LiDAR Quality Assessment Report

LA Jean Lafitte LiDAR

NGTOC

Checkpoint Distribution Image

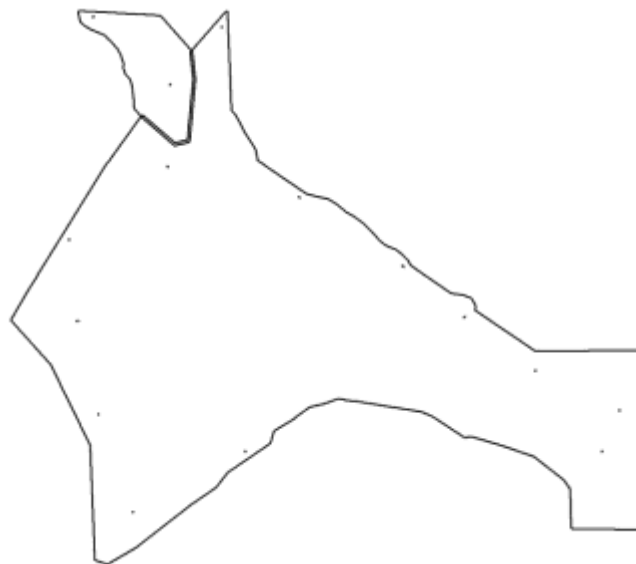
<p><i>Additional Reviewed Vertical Accuracy Information:</i></p>	<p>Due to difficulties accessing swampy interior portions of the project area, the quantity of checkpoints is smaller than required number for each SVA class. USGS accepts the lower number of checkpoints for this project.</p> <p>Vertical accuracy values are for both Barataria and Jean Lafitte combined.</p>
--	---

Based on this review, the USGS accepts the vertical accuracy.
